Item 6 **Amendment to Council Conditions for Subdivision and Rezoning – Parker Lands (Northeast corner of Hurst Way between Asquith Avenue and the CN Railway (River Heights - Fort Garry Ward) File DASZ 12/2018**

A REVIEW of THE ADMINISTRATION REQUIRMENTS: REAR PUBLIC LANES FOR LOCAL ROADS IN LOW-DENSITY AREA OF FULTON GROVE

ATTACHMENT A – Applicant Report, Review of ADMINISTRATION REPORT File DASZ 12/2018 November 2, 2020 and ADMINISTRATION COMMENTS December 2,2021.

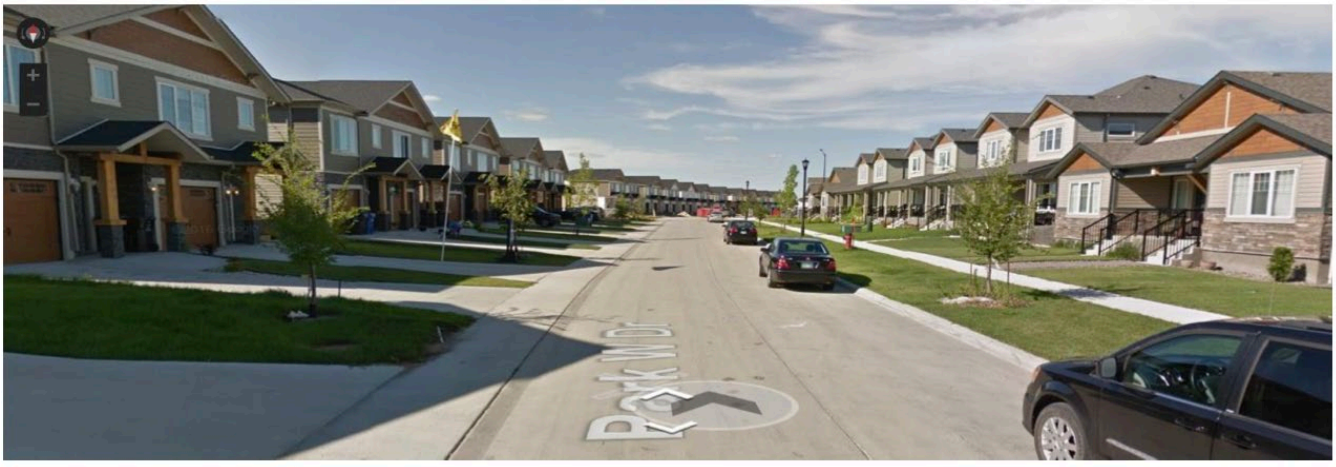
The image below (Figure 7) was taken in Waverley West Town Centre on Park West Drive. It shows a street with front drives on one side and back lane lots on the other side.

Would you feel safe with your child walking on the sidewalk by themselves? – ***Michael Robinson, Senior Planner, November 13, 2018 DASZ Public Hearing****.*

Figure 16: Fulton Grove, Plan of Subdivision, Six Lots.

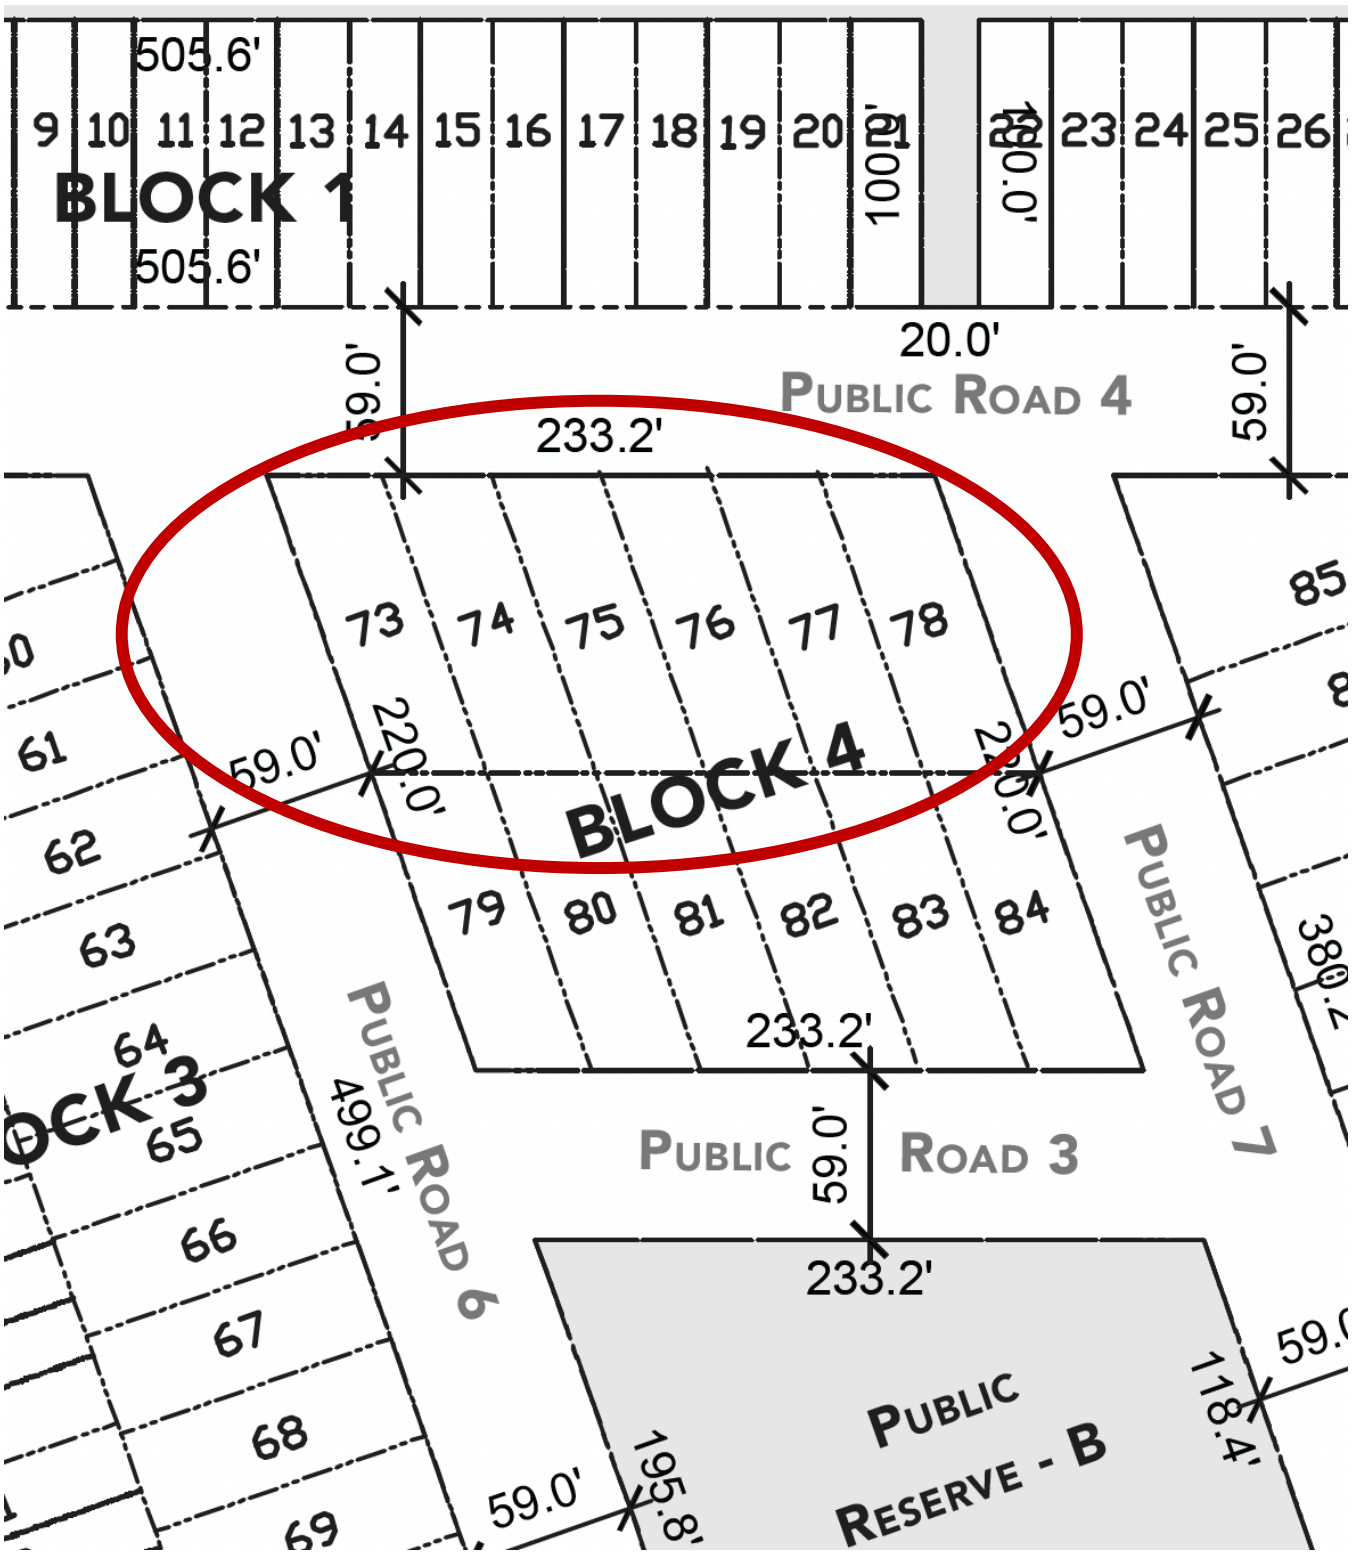
The number of blocks that will be affected was raised this morning. Sidewalks are being provided on both sides of all streets in the low density residential area as per confirmation from City Centre Committee last week. Blocks 3,4 and 5 and those blocks can be seen on the subdivision plan which is in a number of different documents. It is that black and white only plan with the blocks on it. It's not just block 4 but blocks 3,4 and 5 that will have those conflicts that works by my count to 70 properties and that works out to just under 40% of all the low density residential area that will have those conflicts. **[statement made at 3:00.31 – 3:01.54 in the video of the SPC hearing on Dec 2, 2021]**

15. This information is not providing an accurate picture to Council. The scenario the Public Service is stating here regarding the potential issue of driveways crossing sidewalks simply is not pervasive within the Fulton Grove Low-Density Area, and this is not due to the lack of sidewalks since **all streets in this area have sidewalks**: a pedestrian can walk down a sidewalk on all streets without crossing a driveway, **except for six (6) lots** for a distance of **233 feet** – see *Figures 16 and 17.*

16. The Public Service is neglecting significant information here: **only six (6) out of the 187 lots [3.2% of the lots]** have a driveway crossing a sidewalk on a block where no sidewalk exists

17. **ATTACHMENT C** - Side Walk, Public Road and Block Analysis of the Fulton Grove Subdivision is a supplementary report with a breakdown on the details on a street-by-street, block-by-block, lot-by-lot, sidewalk-by-sidewalk, of the concept plan and subdivision plan SUBMITTED October 29, 2018 that illustrates **all streets in the Low-Density Mixed Housing Area have sidewalks with a vast majority having at least one side of the street unimpeded with driveways.** A pedestrian can walk down every single block along one side of the street, and NOT cross a driveway except in front of **six (6) out of the 187 lots [3.2% of the lots].**
